Public Correspondence Item 1- Oppose

From: [Bruce Dunn](#)
To: [McDonald, Hunter](#)
Cc: [trudy@drbronner.com](#); ["eric.peterson"](#); [stephaniwoodward@aol.com](#); [davem@mezieres.com](#)
Subject: Summit Estates Tentative Map
Date: Friday, October 30, 2020 3:38:13 PM

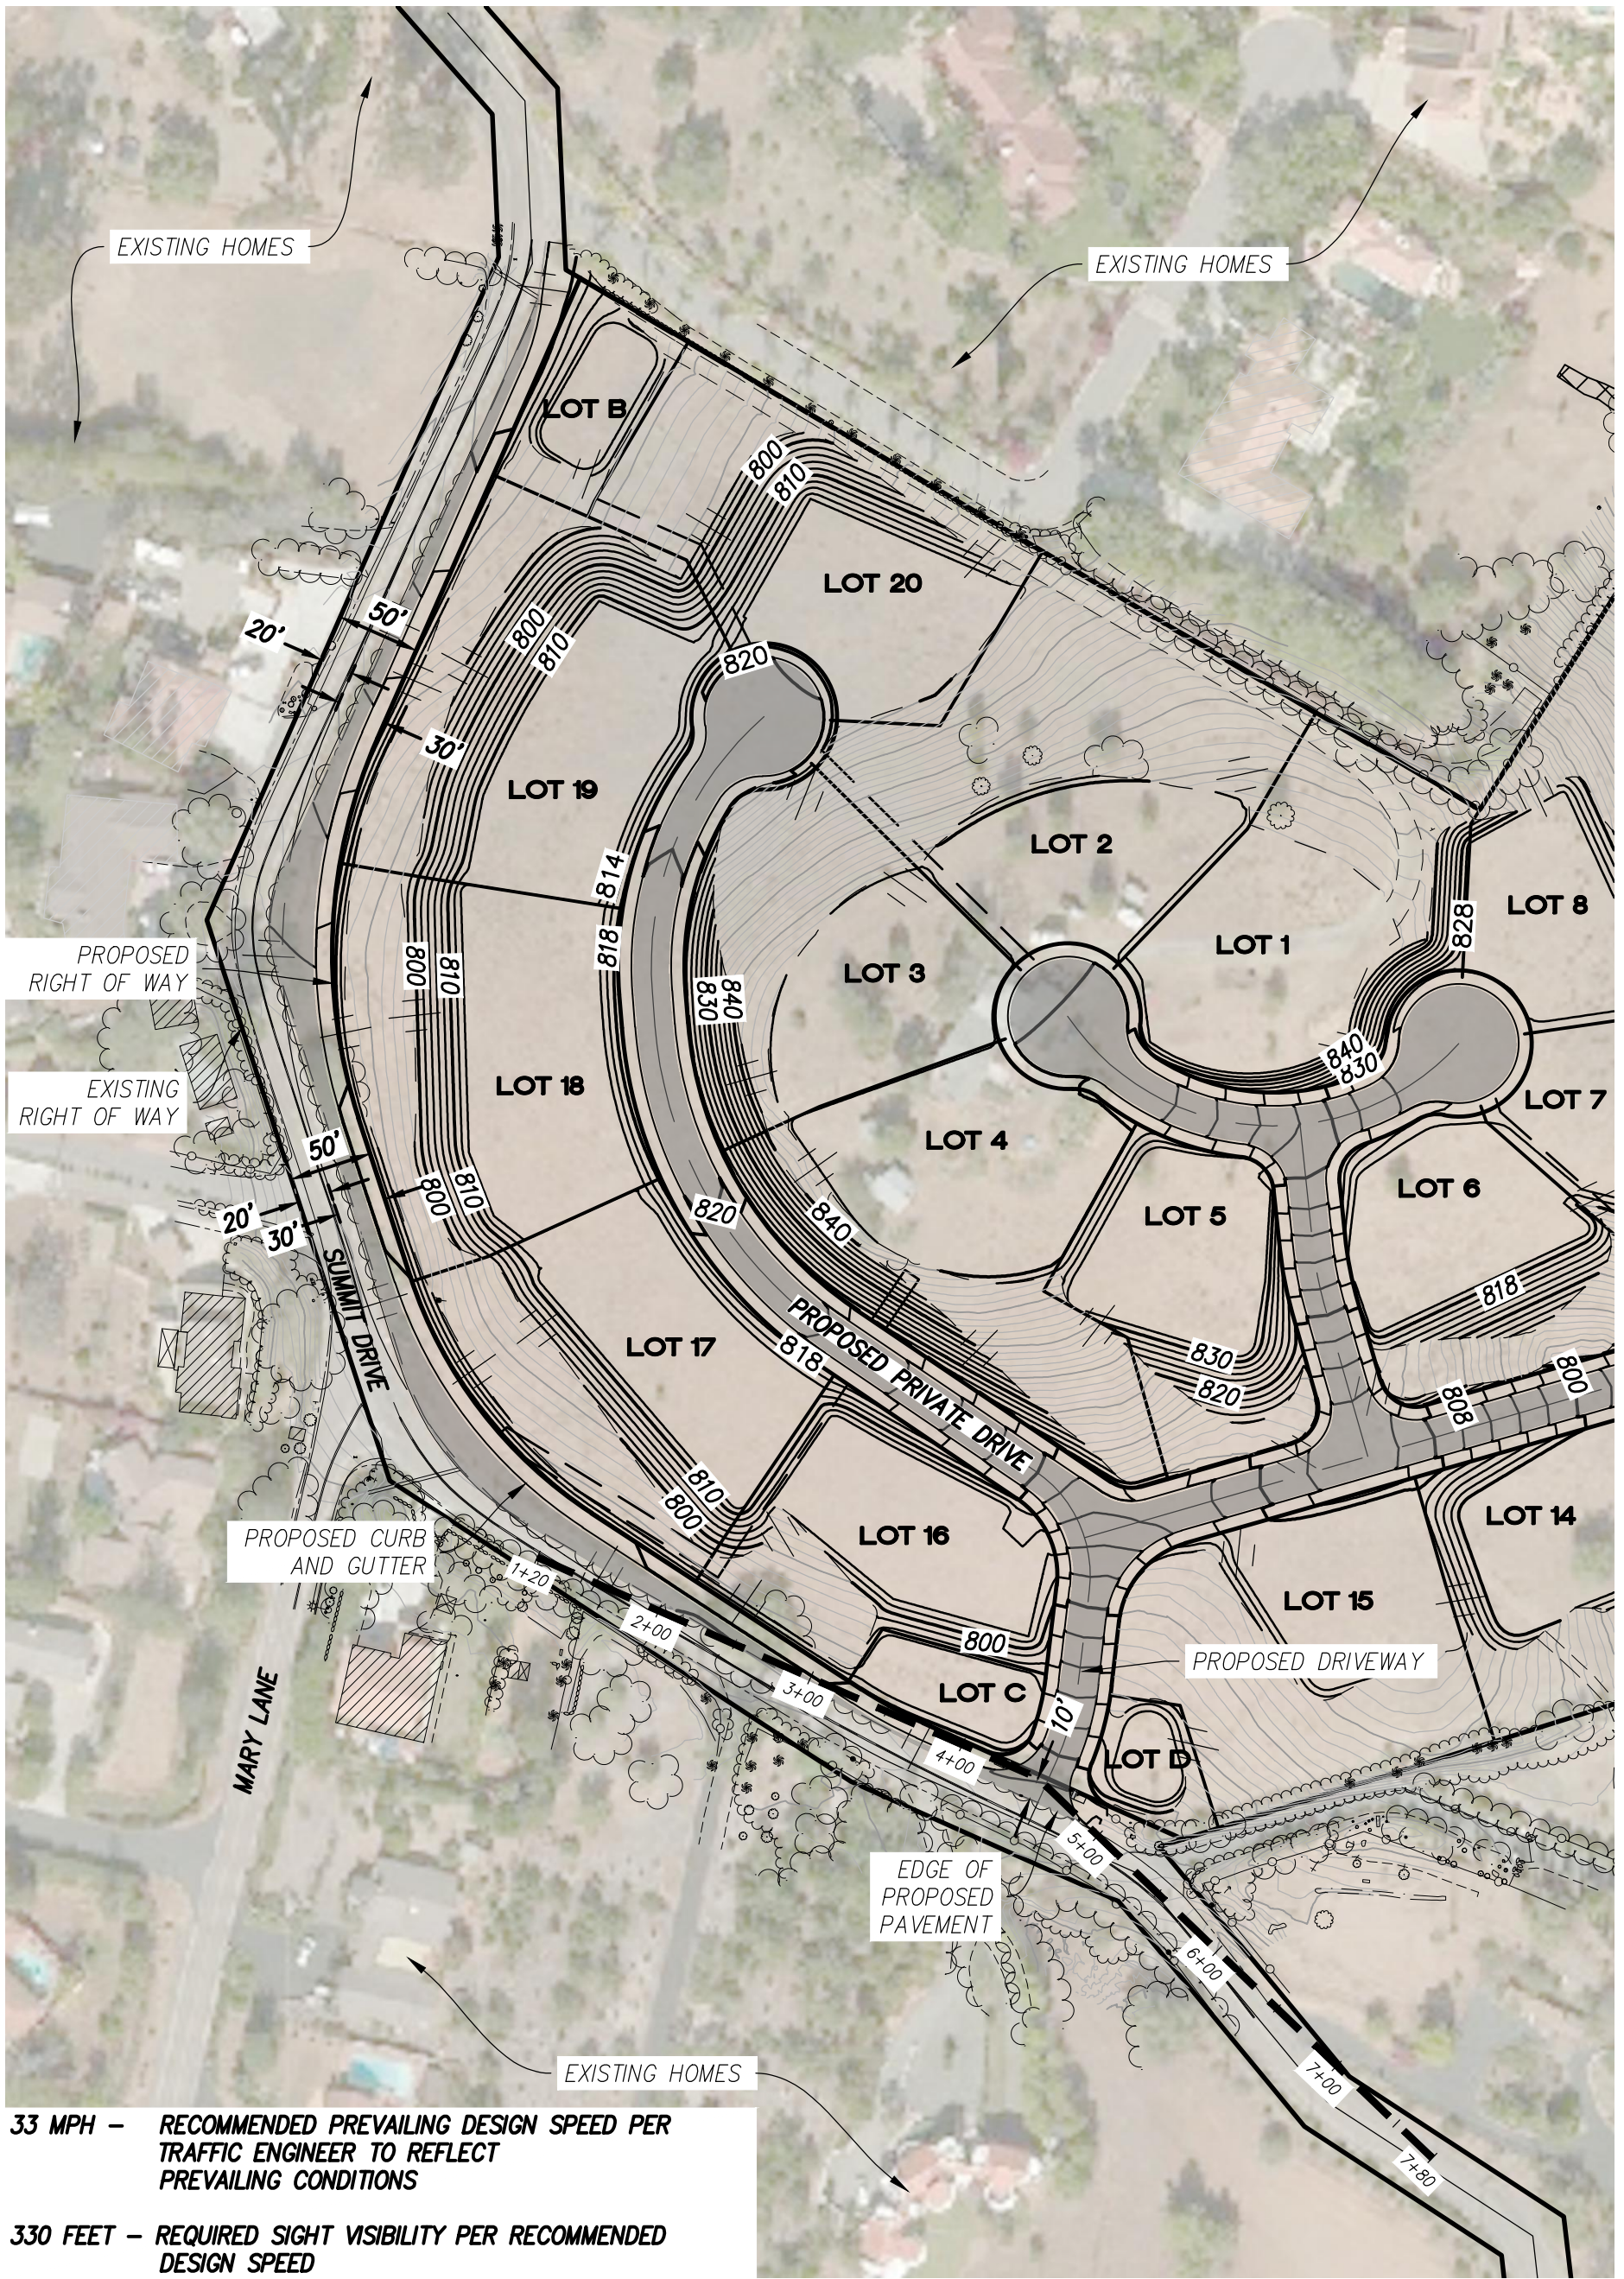
At the January 15, 2020 meeting in Escondido, there was a discussion having to do with the septic system process that is being proposed. We were shown a plan showing the proposed 20 developed lots and the dispersion fields or leach field areas. As the discussion continued it was represent to everyone that the developer would NOT be allowed to place the dispersion fields in disturbed or graded areas on each of the lots and specifically stated that the dispersion fields would be placed on the existing topography left untouched on each of the proposed lots. Since the existing property elevations cannot be disturbed or altered in these proposed dispersion areas it begs the question as to how these fields can be placed in close proximity to Summit Drive, Parcel 1 of PM 14298 and Parcel 4 of PM 14298? Several areas have sloped banks in close proximity to the shown dispersion fields. In fact, the proposed Lot 1 of the development shows the dispersion field almost on the property line of Parcel 4 of PM 14298. What is to keep the effluent from laterally migrating into adjoining properties, slopes and roads? Because of the topography of the area, virtually all of the dispersion fields are on slopes making the threat of washouts very real as the effluent dispersion tubes are installed minimally under the existing grade, usually six to twelve inches.

Normal septic systems have setback requirements from slopes, structures and property lines. The plan given to us at the January meeting does not show any of these setbacks, if required. Are there reserve field requirements for these dispersion fields and if so, why are they not shown on the plan we were given?
